PLANNING AND ZONING COMMISSION SPECIAL MEETING AGENDA MONDAY, AUGUST 2, 2021, 6:00 PM

1. Z202111 – Big Y Foods, owner/ applicant, request for a Special Permit and Site Plan Modification for the construction of a 5,000 sf building for a restaurant and a 5,152 sf building for a four bay car wash on West Road, APN 046-001-0000 and APN 037-004-000 in a PC - Planning Commercial Zone.
2. Z202112 - Text amendment to Section 3.1.2 – Residential Uses, Section 7.1 Accessory Apartments and Section 10.2 - Definitions of the Ellington Zoning Regulations.

SUBJECT: Recommendations from Design Review Board for design elements for Z202111 – Big Y Foods, owner/ applicant, request for a Special Permit and Site Plan Modification for the construction of a 5,000 sf building for a restaurant and a 5,152 sf building for a four bay car wash on West Road, APN 046-001-0000 and APN 037-004-000 in a PC - Planning Commercial Zone.

Lisa, please find Site Plans revised (revision date 07/22/2021) to address town staff comments and written responses to comments. Town staff comments in normal font, responses in **bold font**.

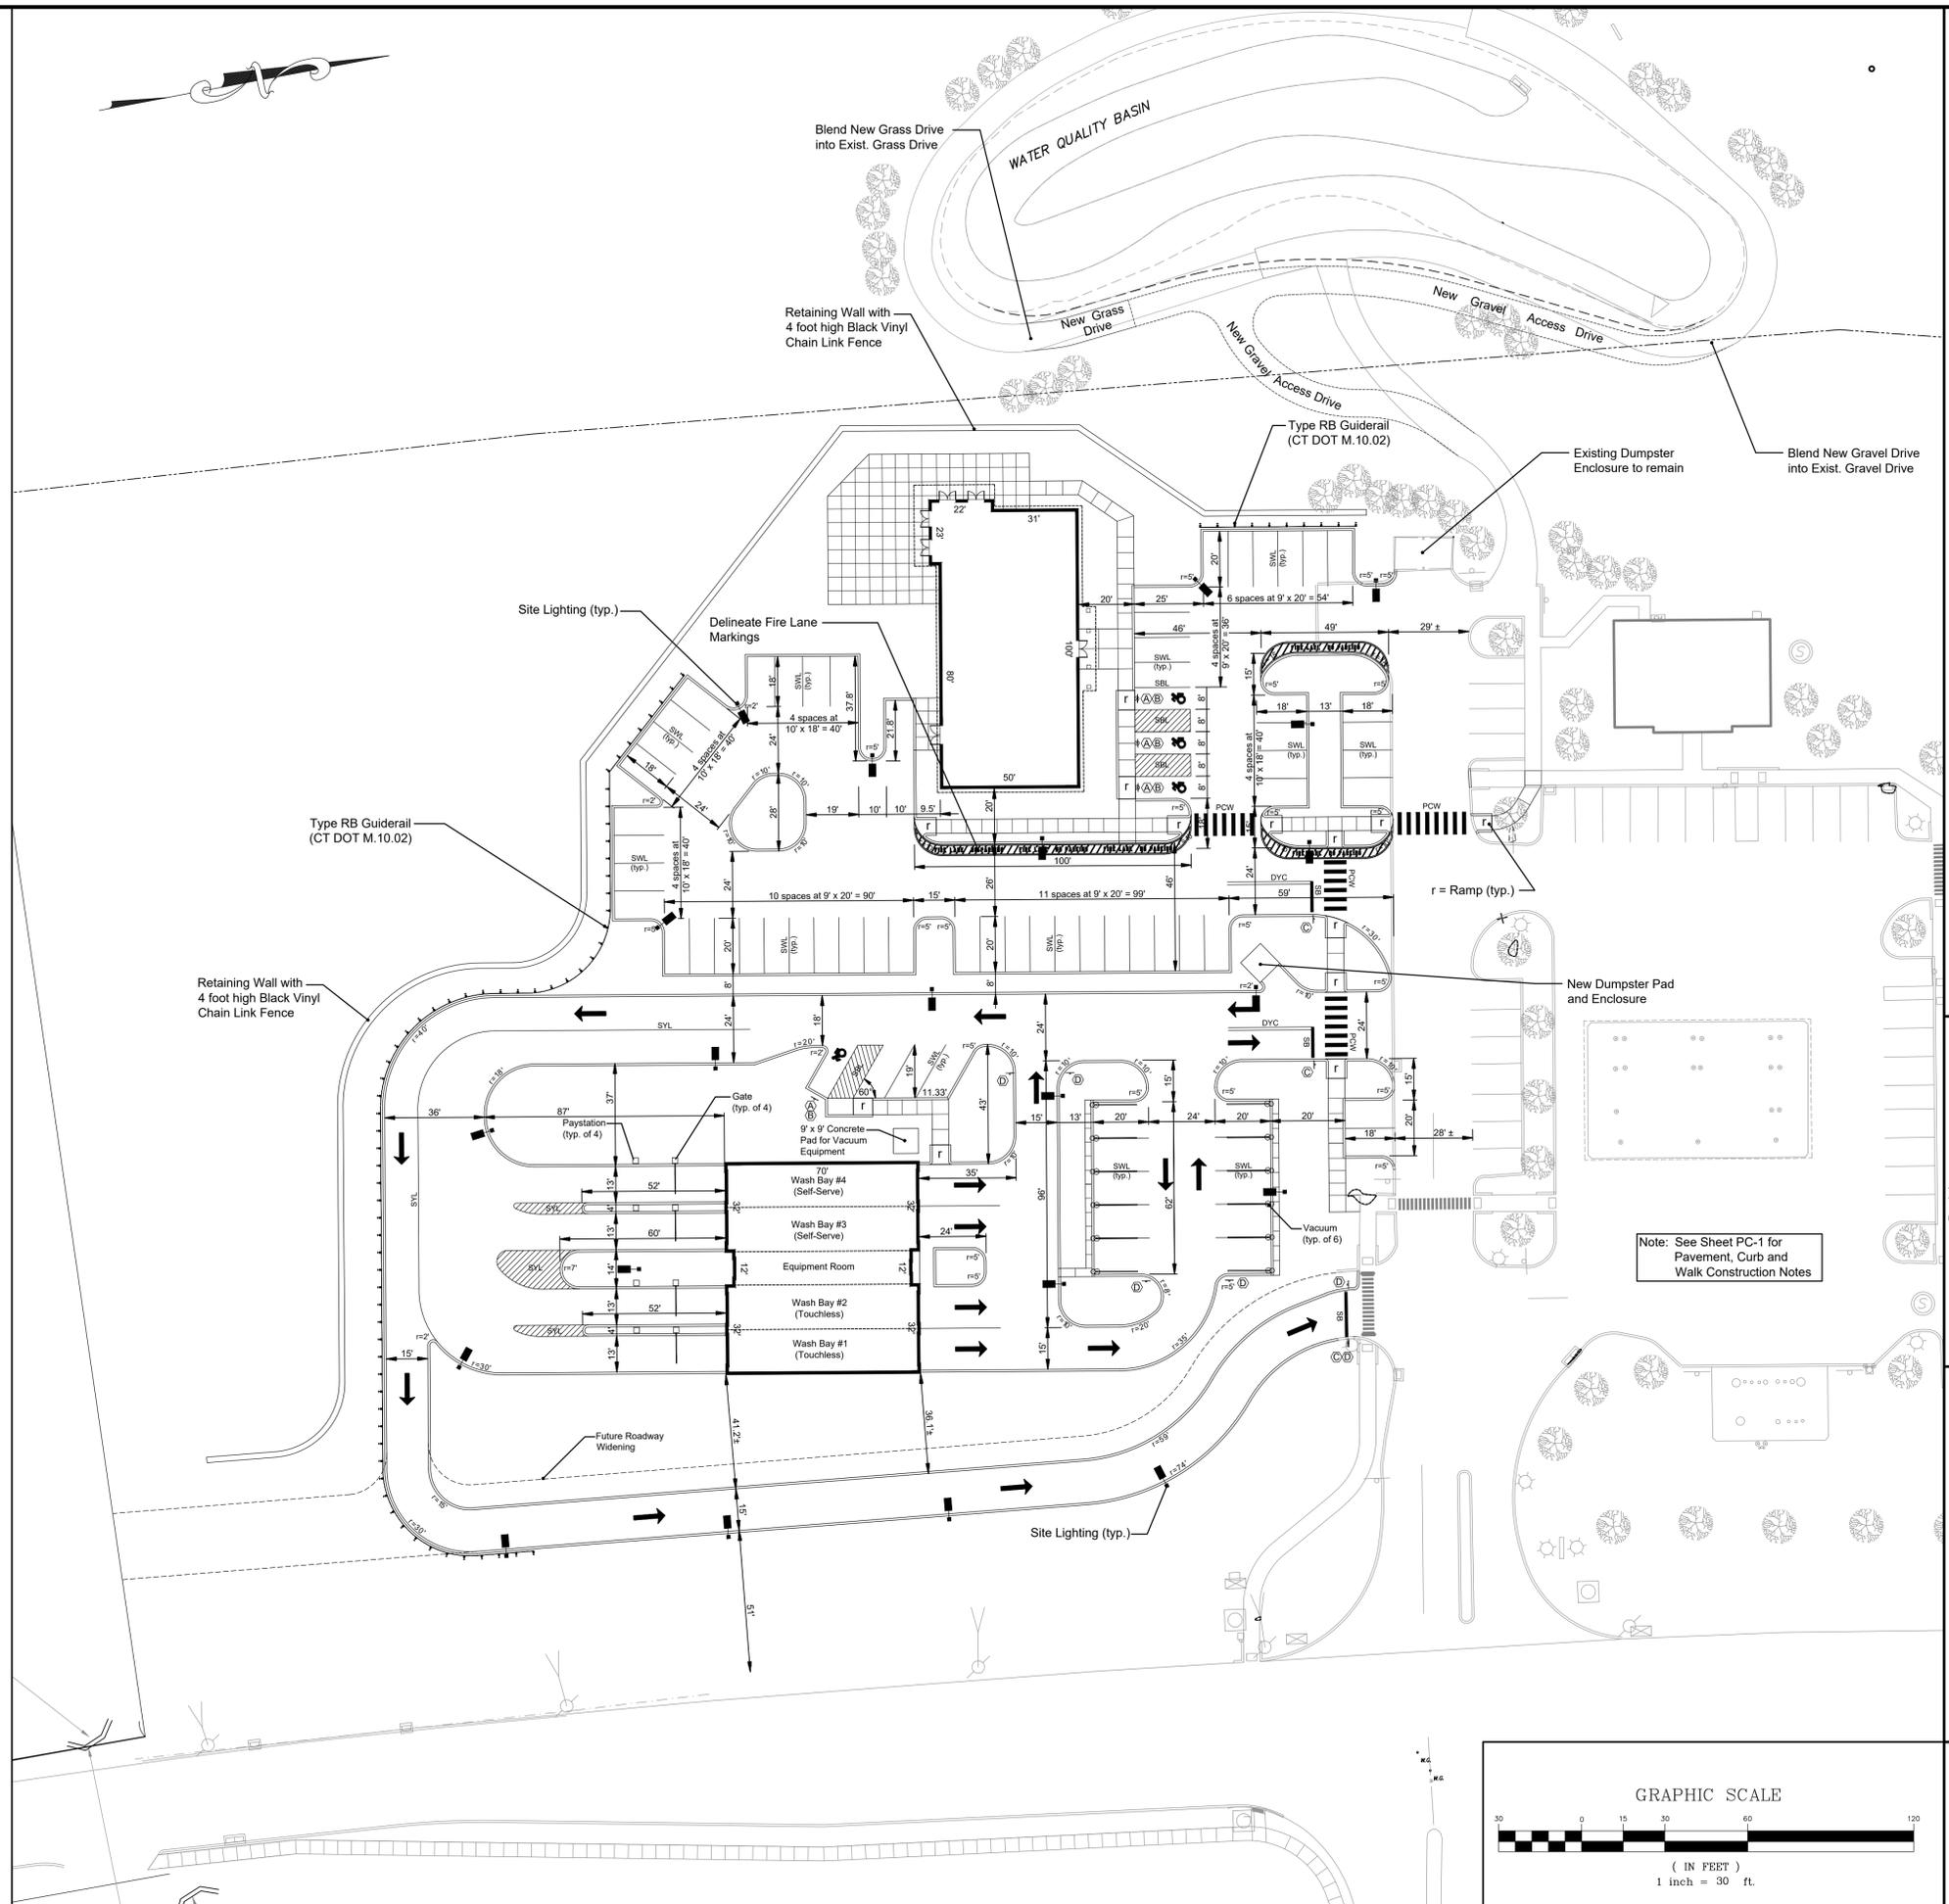
The Plan has been revised to allow circulation of the required fire apparatus (town's ladder truck) by increasing the width of the "dog bone" island north of the restaurant's main entrance (by 5 feet) to allow circulation of the apparatus around the island and through the parking area. In addition, the drive east of the east end of the restaurant has been widened to 26 feet adjacent to the restaurant to accommodate fire apparatus. These changes were acceptable to Mr. York.

The Plan was revised to include fire lane markings east of the restaurant and at the ends of the "dog bone" island north of the restaurant's main entrance.

The Plan has been revised to reflect these changes. (See Sheet LA-1).

These were added at the request of Mr. York. The changes are depicted on Sheet LA-1. A detail of the fire line striping was provided by the EVFD and added to Sheet SD-1.

SOIL EROSION AND SEDIMENT CONTROL PLAN	
No.	Date
1	07-22-2021

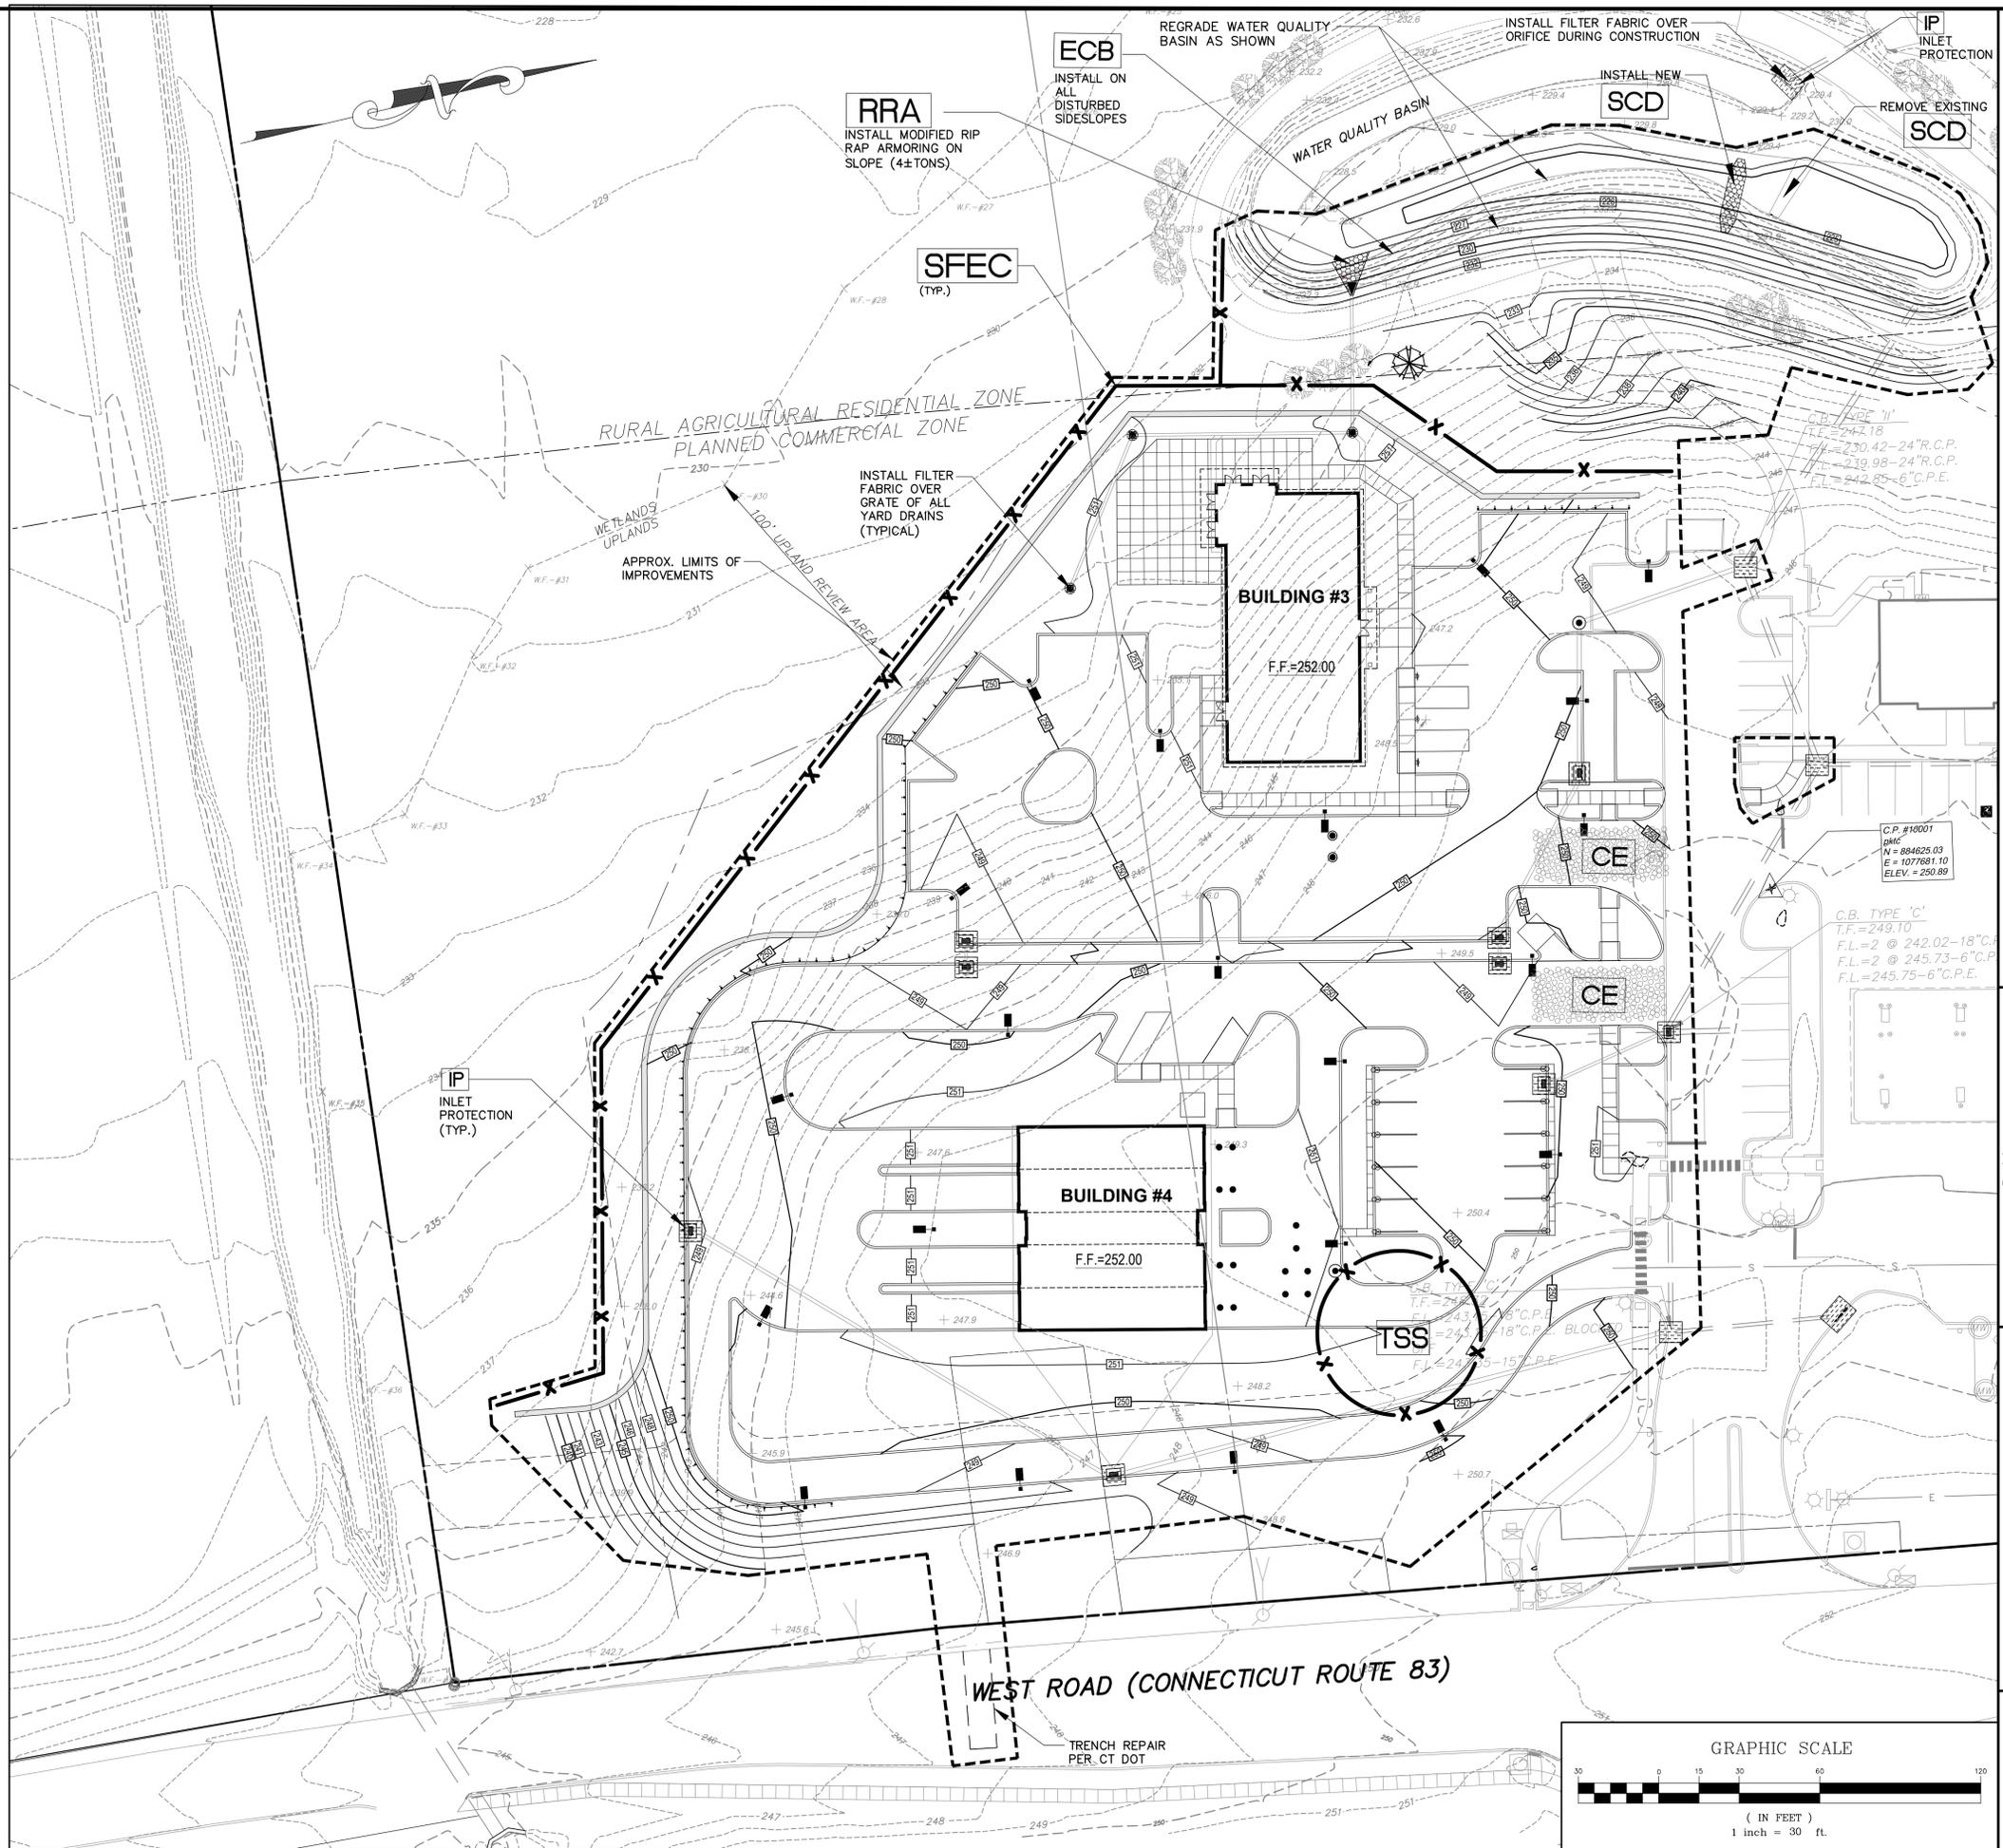
4. The Erosion Control Plan (EC-1) notes a riprap plunge pool at the outlet from YD#20A onto a side slope. Plunge pools need to be located on a level surface. Provide riprap armoring down the slope and level spreader or plunge pool in the bottom of the basin.

The Plan has been revised to address. A flared-end section was added to the pipe outlet and the rip rap plunge pool depicted on Sheet EC-1 was replaced with rip rap armoring and a note detailing the size and quantity of the armoring was added to Sheet EC-1. Sheet GR-1 was revised to show the flared-end section.

**NYLOPLAST YARD DRAIN
CONFIGURATION & INSTALLATION**

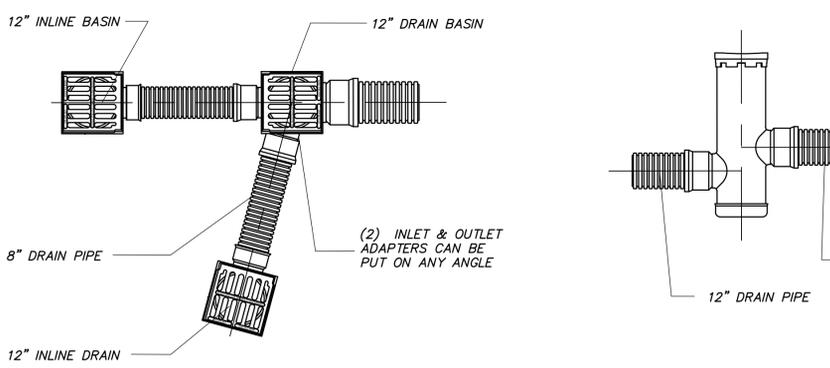
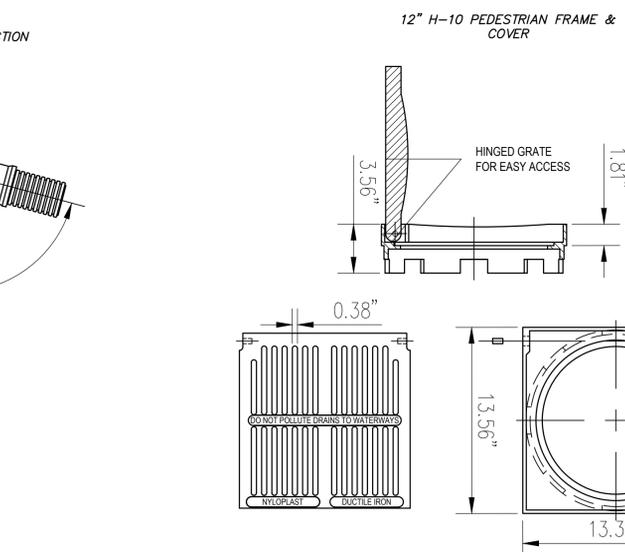
1. Specify the diameter of the Nyloplast yard drain risers behind the restaurant on Grading Plan (GR-1).

2. Lower the flowline of yard drain #20A or clarify how the outlet pipe will pass under the bottom of the retaining wall (GR-1).

The Plan has been revised to address. More detailed design information has been added to Sheet GR-1. Additional details for the Nyloplast drains have been added to Sheet SD-5.

The Plan has been revised to address. More detailed design information has been added to Sheet GR-1. Additional details for the Nyloplast drains have been added to Sheet SD-5.
